Changes to FPC Tails for FT Series 5-Wire Analog Resistive Touch Screens

The Plating Material for FPC Tails of FT Series Touch Screens will be Changing

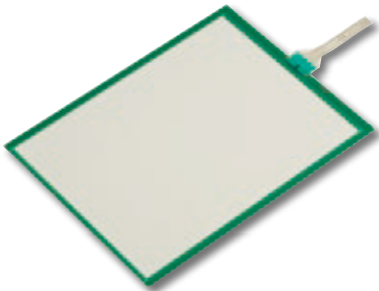
FT Series Touch Screens will be undergoing changes to plating on the FPC tails. This revision will apply to the analog resistive 5-wire touch screens, including both standard and custom models. The tin plating material on the tails will change to gold plating, which will be a different color, as shown on the following table. The three effected standard part numbers are displayed below.

Before Change	After Change
<p>FPC Tail Top & Side Views</p> <p>Diagram labels: Contact Side Copper Foil with Tin Plating, Reinforcement Film, Tail. Dimension: (0.3)±0.05, .012.</p> <p>Tail with Tin Plating</p>	<p>FPC Tail Top & Side Views</p> <p>Diagram labels: Contact Side Copper Foil with Gold Plating, Reinforcement Film, Tail. Dimension: (0.3)±0.05, .012.</p> <p>Tail with Gold Plating</p>

Changes for the FT Series 5-Wire Analog Resistive Touch Screens FPC Tail Plating will be effective February 2025. However, the date may be subject to change depending on inventory of the products.
